Attachment A

STANDARDS FOR INTERCONNECTION OF DISTRIBUTED GENERATION

Commented [A2]: We have not updated this table. In order to make this redline easier to reference we removed page breaks and other formatting in places to allow edits to flow the subsequent pages. We also added page numbers for ease of reference.

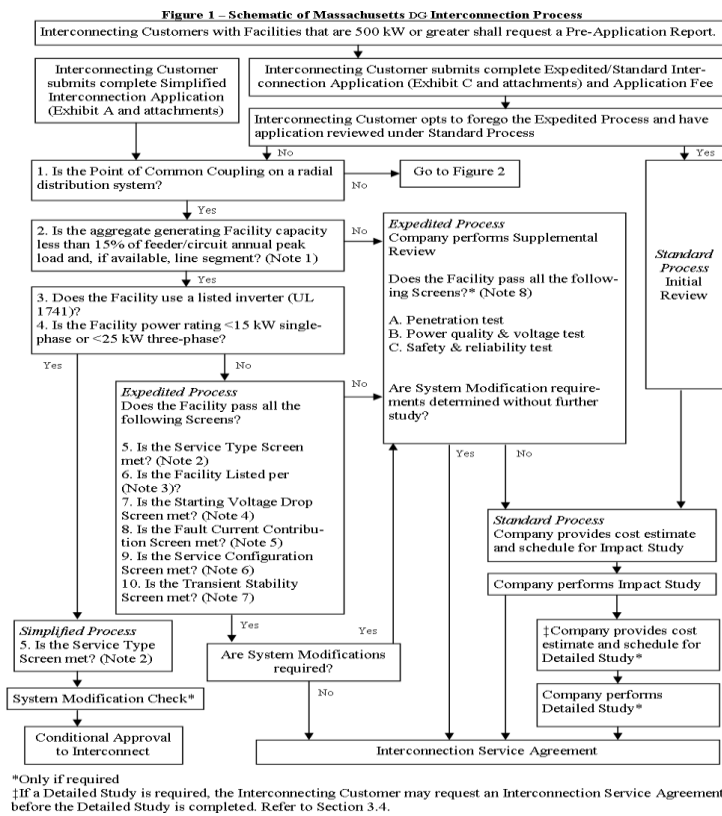
Commented [A17]: Figure 1 (flow chart) below will need to be revised and replaced pursuant to the agreement reached by the TSRG and the additional recommendations made in our comments.

The JESS also recommends that the DPU adopt a new flow chart but also include the precise screen language in the text along with the notes. It is often confusing and difficult to interpret the screens when the language is both found in the table and in the notes.
